Project Name : Bilsham Road, Yapton

Job No : 19-326

Note Title : Drainage Strategy Addendum No. 1

Job Title			
BILSHAM ROAD, YAPTON			
Drawing Title			
PRELIMINARY ENGINEERING LAYOUT. SHEET 2 OF 2			
Client			
BILSHAM ROAD DEVELOPMENT LLP			
Scale	Date	Designed	NA
1:500 @A0	FEB 20		
Drawn	Checked	Approved	GG
LS	JH		
Job No	Drawing No	Rev	
19-326	19-326/010	K

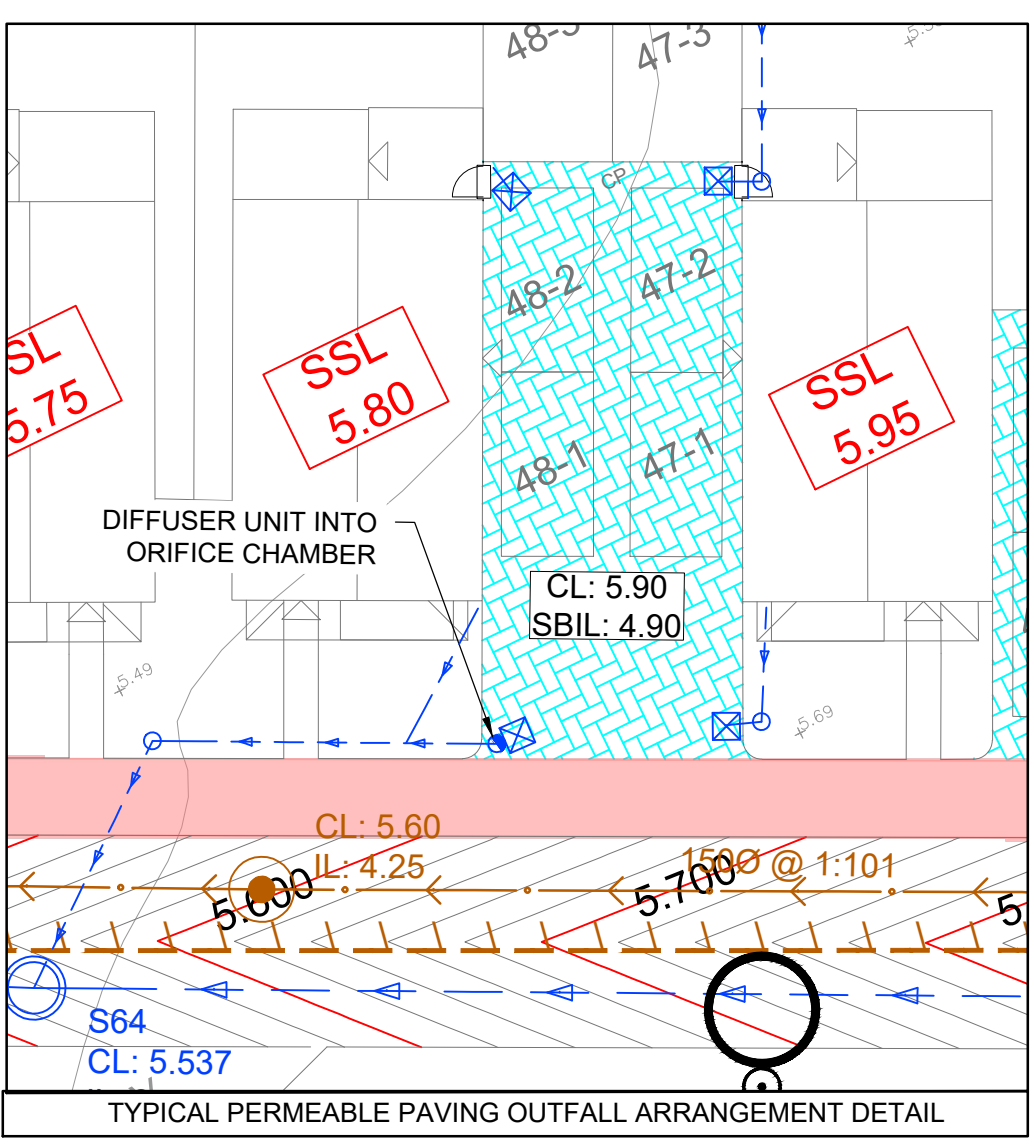
“Groundwater monitoring results must be provided and should be overlaid on detailed drainage layout drawings.”

“All pipes must be labelled with diameters and falls.”

“Manhole invert and cover levels must be provided.”

“Note to be added to drawing to state that watercourses will be cleared of vegetation and silt as part of works. These works must be completed near the beginning of construction to ensure the free flow of water.”

2.1.3 The results of groundwater monitoring are provided in **Drawings 19-326/009 and 19-326/010** in **Appendix B**.

2.1.4 The diameters of the proposed pipes were included in the submitted drainage strategy drawings. The falls have been added to show the gradient of the pipes, and are shown in **Appendix B**.

2.1.5 The invert and cover levels of the proposed manholes are shown in **Appendix B**.

2.1.24 A note detailing the works to the watercourses has been added to the drawings in **Appendix B**.

Flotation Calculations

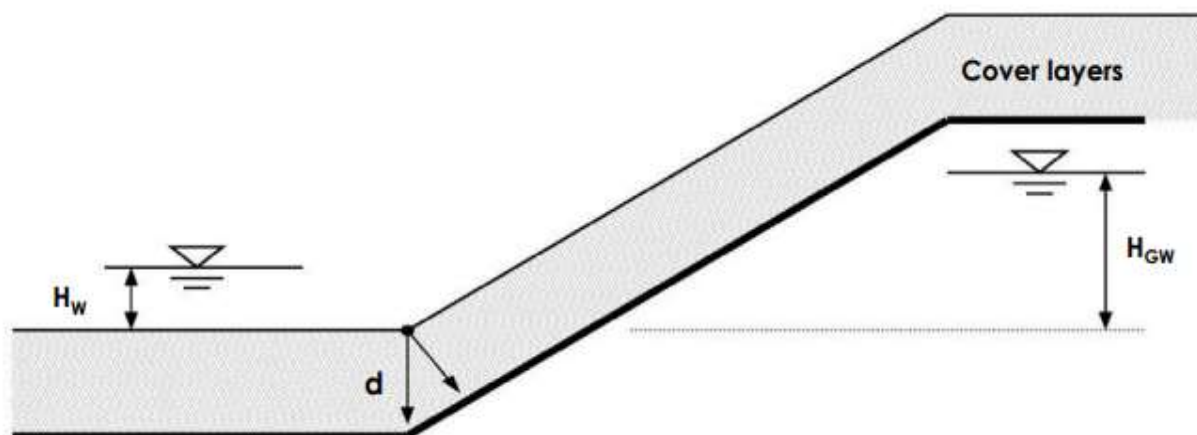
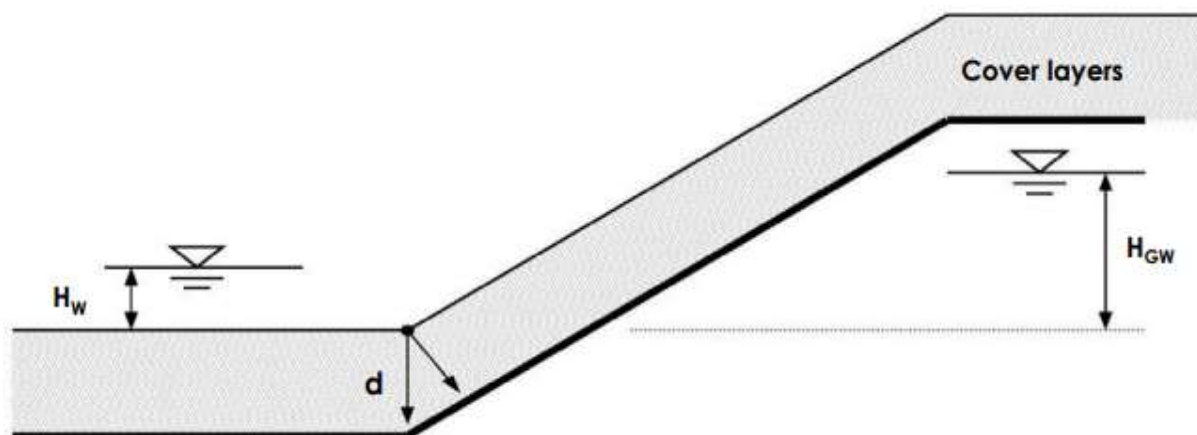
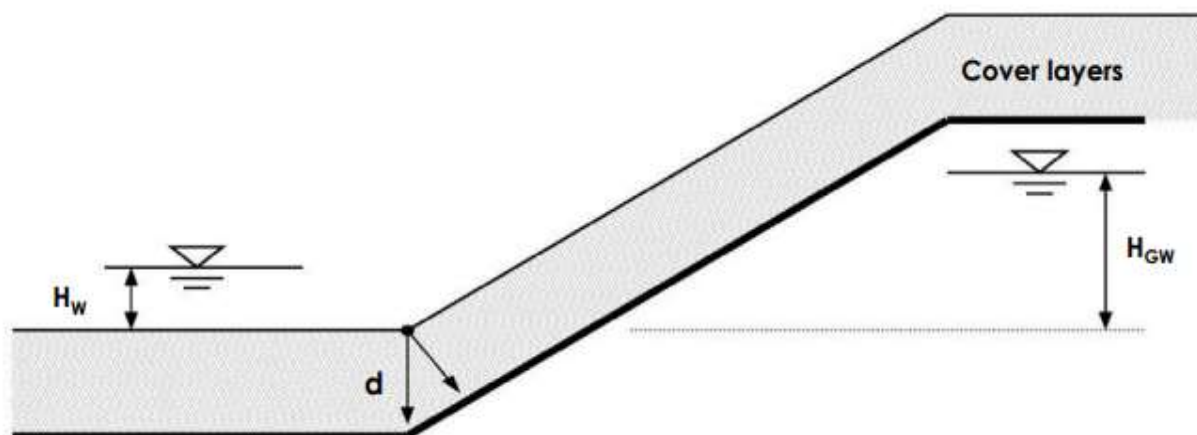
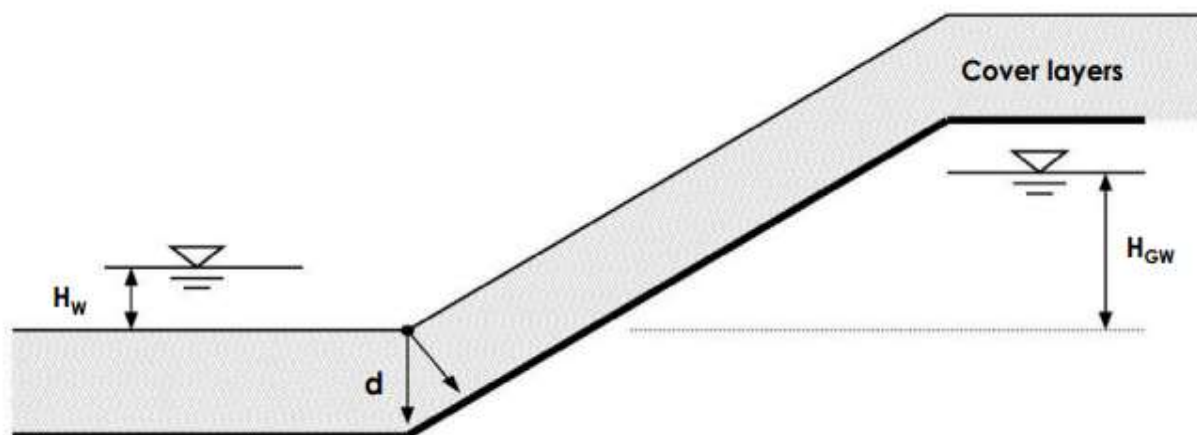
“Please clearly identify which features are to be lined and which are not. Please supply flotation calculations for lined features.”

2.1.19 The basins would require lining to protect against buoyancy. The flotation calculations are provided in **Appendix E**. A hybrid approach would be adopted with the permeable paving, whereby surface water runoff would be attenuated and discharged at the approved Qbar rate to the watercourse network, whilst allowing infiltration in areas where permeable paving is located above recorded groundwater levels.
